MARY RIVER – TOTE ROAD ROUND CSP CULVERTS

REQUEST FOR APPROVAL BY DESIGN OFFICE FOR
CHANGE

Date:	April 17, 2024	File No.:	NB102-00181/77-A.01
		Cont. No.:	NB24-00434
To:	Mr. Jim Patterson		
Copy To:	Connor Devereaux, Rudolf Dietrich		
From:	Greg Johnstone		
Re:	CV-216 Design Change due to Massive Ice

Date:	April 18, 2024	File No.:	NB102-00181/93-A.01
		Cont. No.:	NB24-00444
To:	Baruck Wile Rudolf Dietrich		
Copy To:	Dale Tulloch Jim Patterson Sharon Dyke Michael Burns SCP Admin BIM Document Control		
From:	Greg Johnstone		
Re:	Permanent Crossing Plan - Round CSP Culverts, Response to Request for Information (RFI) No. 014

Figure 1 Approximate area of placed Culvert Infill Material containing snow at BG-04 Culverts shown in red (From Drawing 745 R2)

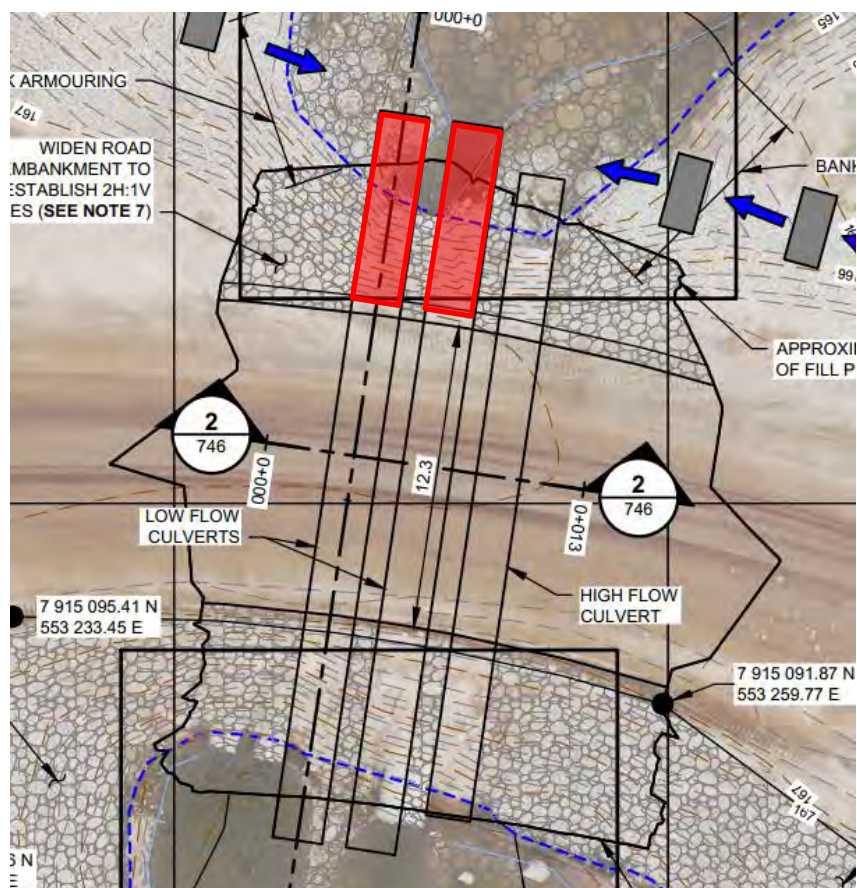
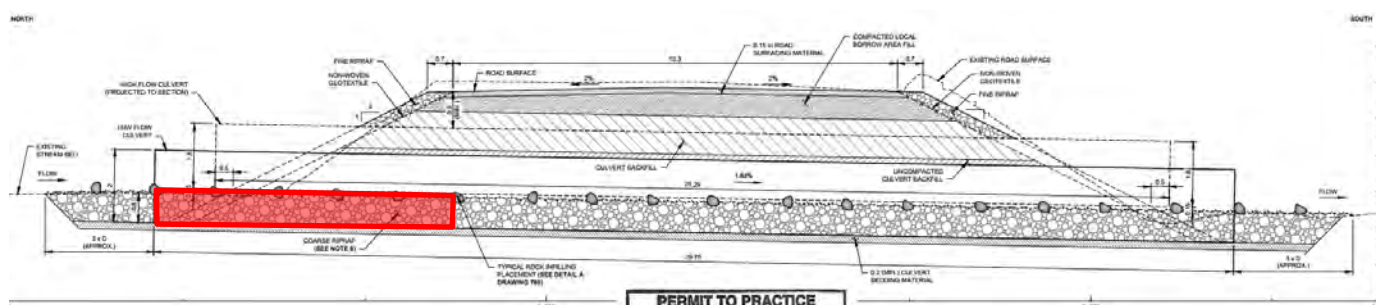
During the beginning of nightshift of April 2, 2024, it was observed that the Culvert Infill Material being placed by Nuna to backfill the inside of the two (2) low flow culverts at BG-04 contained entrained snow (See Figures 1 and 2). The material with snow was observed along the first 8 m from the inlet ends of both low flow culverts. Further review identified that the stockpiles of both the Stream Substrate Material and the Coarse Riprap had snow mixed into the stockpiled materials.

The placed Culvert Infill Material within the identified area of the two (2) low flow culverts at BG-04 therefore did not appear to meet the technical specifications identified in Note 3 on Drawing No. 703, Rev 3 (Permanent Crossing Plan Culvert Fill Materials and Geosynthetics Specifications).

It is KP's official recommendation that the material in question be removed from the identified areas of the two low flow culverts at BG-04. This material should be replaced by more suitable Stream Substrate Material without an excess of snow and/or ice. This solution is considered lowest risk of non-compliance with DFO requirements.

However, based on a discussion with Baffinland, Nuna and KP on April 11, it was agreed that a test of applying heat or heating and steam combined to the Culvert Infill to melt the entire snow/ice would be conducted to a portion of the non-compliant infill material as an initial step. The next steps would be determined based on an assessment of the effectiveness of this test.

Figure 1 Approximate area within the low flow culverts at BG-04 that lack the required Boulder Clusters and Protruding Boulders shown in red (From Drawing 745 R2)

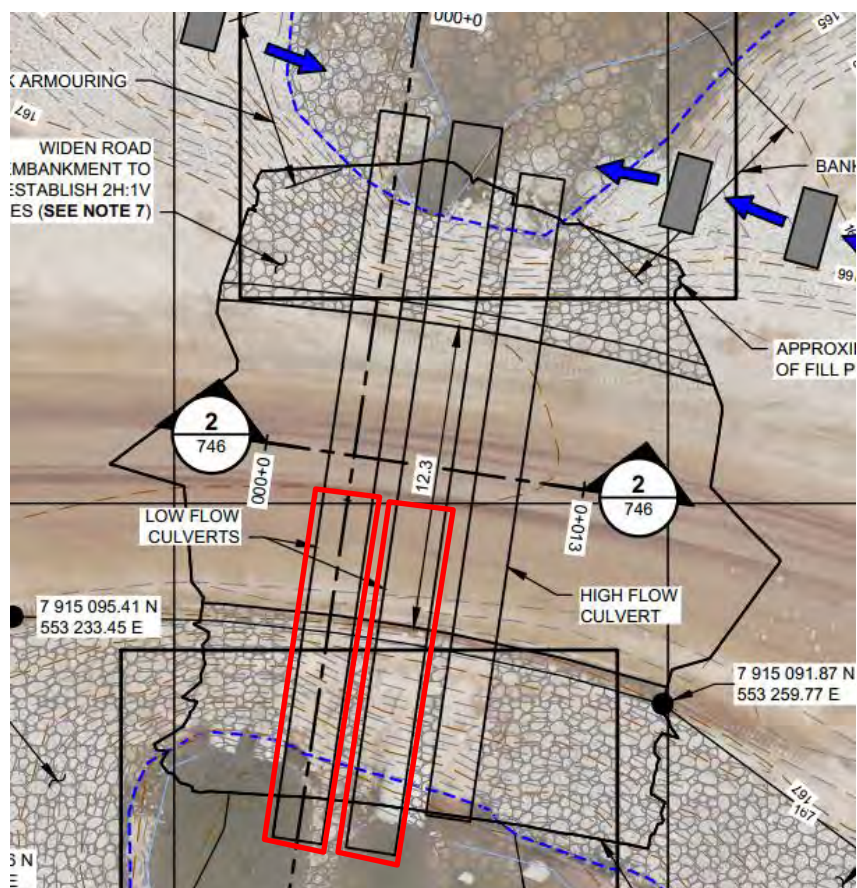
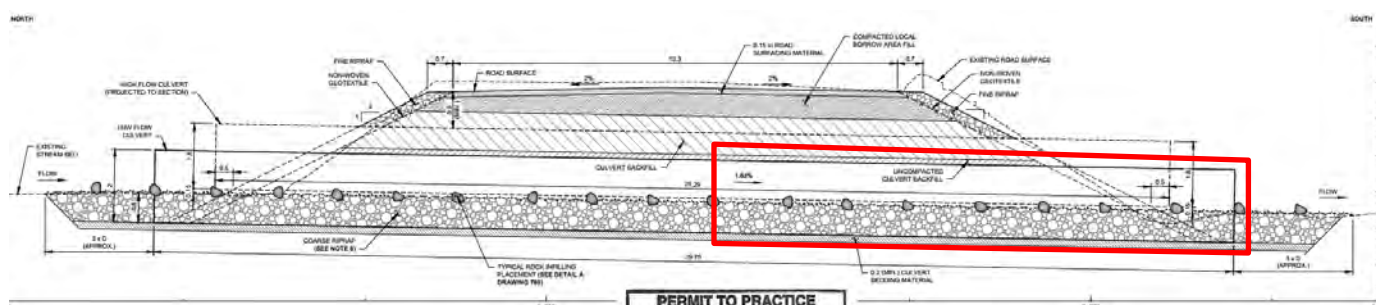
As per Drawing No. 746, Boulder Clusters are required to be installed at a spacing of 3.5 m within the low flow culverts at BG-04. Additionally, protruding embedded boulders are to be field fit within the culvert as specified by the engineer. Boulder Clusters and Protruding Boulders were installed as per the design in the northern half of the low flow culverts at BG-04; however, the required Boulder Clusters and Protruding Boulders were not installed properly within the southern half of the low flow culverts.

The Boulder Clusters that are present in the southern half of the northwestern low flow culvert require replacement as they are not installed as per the design specifications on Drawing No. 780 (See Photo 1). The boulders placed are too small and not properly imbedded to prevent movement during high flow conditions. There are no Boulder Clusters or Protruding Boulders currently present in the southern half of the southeastern low flow culvert (See Photo 2).

The Boulder Clusters are necessary to provide a velocity shadow (resting place) for fish passing through the culvert. Without the Boulder Clusters, the fish passage parameters such as maximum swim distance and flow velocity are exceeded. The fish passage parameters must be met for each culvert to be in conformance with the Department of Fisheries and Oceans (DFO) corrective measures order.
